REFER TO BULLETIN SER 74 GEN-17

Front fork disassembly and assembly procedures for the S3, H1, H2, Z1, KX250, and KX450 (1974 models) vary from those outlined in the current shop manuals.

REFER TO BULLETIN SER 74 GEN-16

1974 STYLE

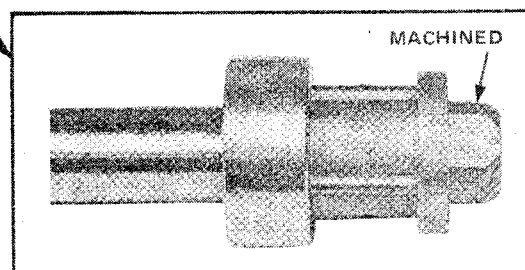
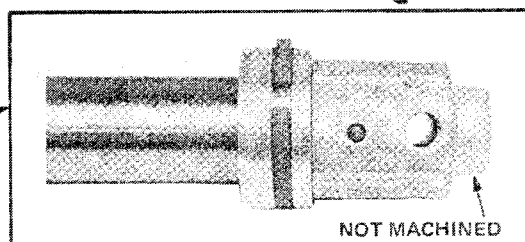
The cap of the 1974 style fork damper cylinder (except KX250) is not machined to fit the fork cylinder holding tool.

NOTE: The 1975 fork damper cylinder remains identical to the 1974 style except the cap is again machined to allow use of the holding tool.

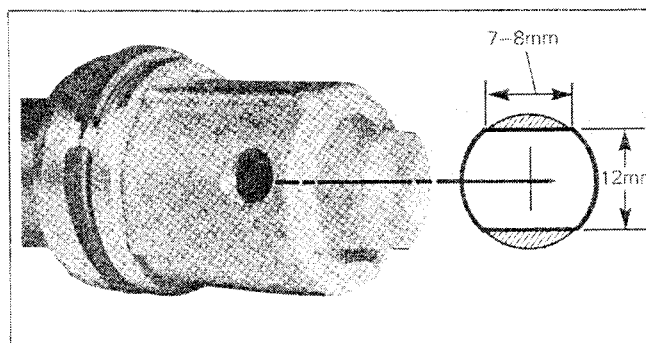
File two flats opposite each other into the 1974 style damper cylinder cap. The damper cylinder holding tool can then be used for future disassembly.

H SERIES

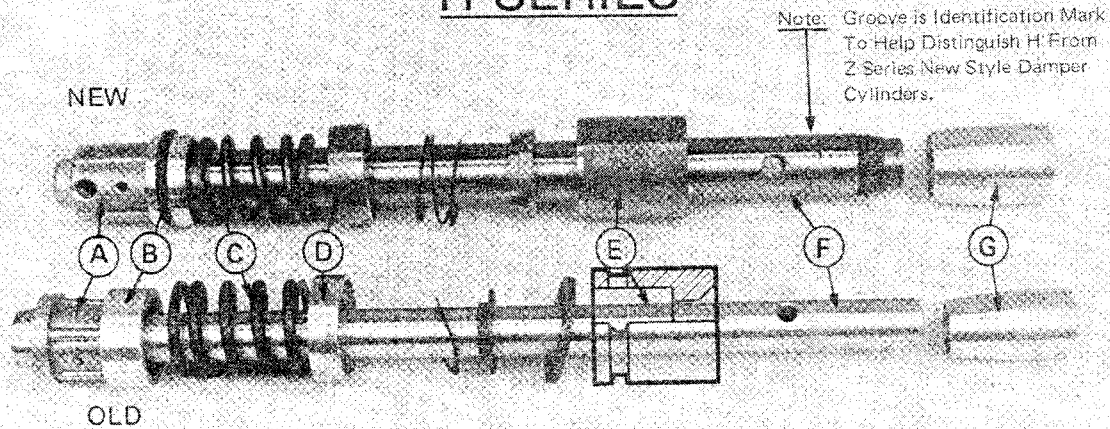
A DAMPER CAP	B PISTON	C REBOUND CUSHION SPRING	D VALVE	E FORK PISTON	F CYLINDER	G TAPERED CYLINDER BASE
NEW	CLOSED TOP	PHENOLIC PISTON RING	30mm LONG	STEEL	P/N 44018-009	STEEL 17mm DIA.	ALUMINUM 22mm DIA.
OLD	OPEN TOP	NO RING	33mm LONG	ALUMINUM	P/N 44018-003	ALUMINUM 13mm DIA.	ALUMINUM 18mm DIA.

Z SERIES

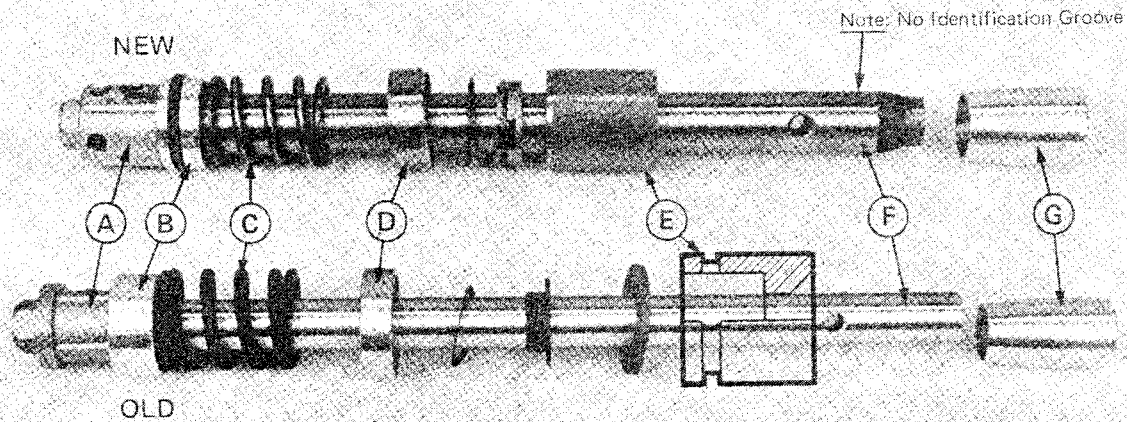
A DAMPER CAP	B PISTON	C REBOUND CUSHION SPRING	D VALVE	E FORK PISTON	F CYLINDER	G TAPERED CYLINDER BASE
NEW	CLOSED TOP	PHENOLIC PISTON RING	30mm LONG	STEEL	P/N 44018-009	STEEL 17mm DIA.	ALUMINUM 22mm DIA.
OLD	OPEN TOP	NO RING	33mm LONG	ALUMINUM	P/N 44018-003	ALUMINUM 13mm DIA.	ALUMINUM 18mm DIA.
